Access Compliance Report

(Curb Ramps)

| Intersection ID: 14144 | Main Street: BRIAR_CREEK_RD | Cross Street: GREEN_OAKS_LN | Location: | N |
| ADA ID: 8C28F04DCDA7 | Ramp Type: Perp | Initial Pass/Fail: Fail | Overall Compliance: No | Severity Score: 37.5 |

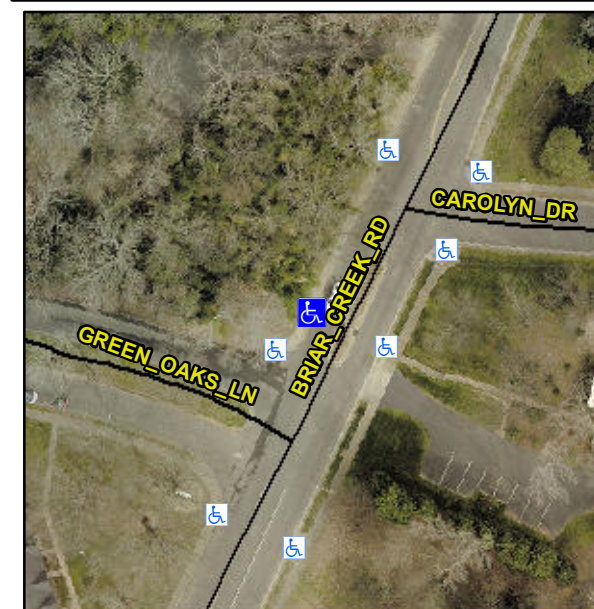
Not Found, R304.2.2, R304.5.3

| Compliance | Description | Data | Compliance | Description | Data |
|------------|-----------------------|-------|------------|-----------------------------|------|
| N/A | Ramp Length (in) | 50.0 | No | Ramp Slope (%) | 12.4 |
| Yes | Ramp Width (in) | 48.0 | No | Ramp XSlope (%) | 5.1 |

Remove & Replace Entire Ramp.
